BLUE CUT 12KV
TD1679153
12-31-25
RAIL ROAD

PROPOSED CONSTRUCTION (LOCATION)
BLUE CUT 12kV & VERDEMONT 33kV
CAJON BLVD & KENWOOD AVE
SAN BERNARDINO

ASPLUNDH MAP REVISIONS IN RED 8-7-2025 JM/CS

SHEET 2 OF 4 | JOB NO. 1257956_0.01

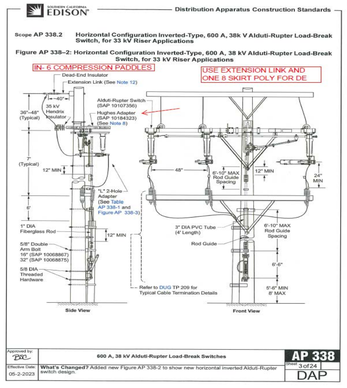
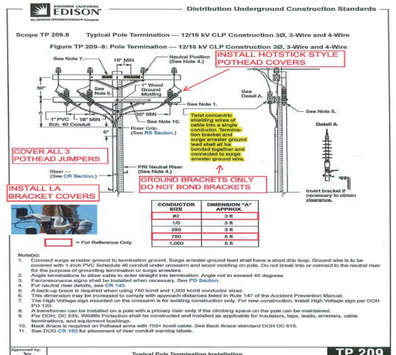
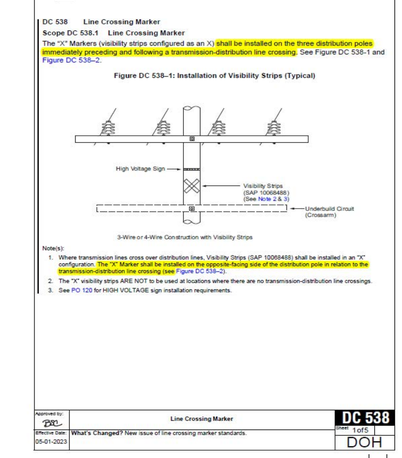
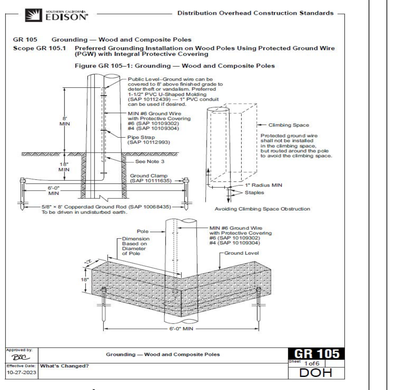
PER NOTIFICATION 904
INSTALL HIGH SIGNS

PER NOTIFICATION 904
INSTALL VIS STRIPS

INSTALL TRANSMISSION CROSSING VIS STRIP X BELOW TOP ARM FACING AWAY FROM TRANS POLE 3 POLES OUT FROM TRANSMISSION CROSSING

REPLACE GREY CUTOUT COVERS TO PINNED STYLE COVERS

IN–6- COVERED JUMPERS
IN–6- COMPRESSION PADDLES

INSTALL RISER WARNING STICKER

INSTALL AQUA SEAL ON COMPRESSION SLEEVES AND TAPE UP WITH 33 TAPE

REPLACE GREY CLAMP COVERS TO HOTSTICK STYLE POTHEAD COVERS AND LA BRACKET RAPTOR COVERS

#IN–3- HFA 33kV LA'S
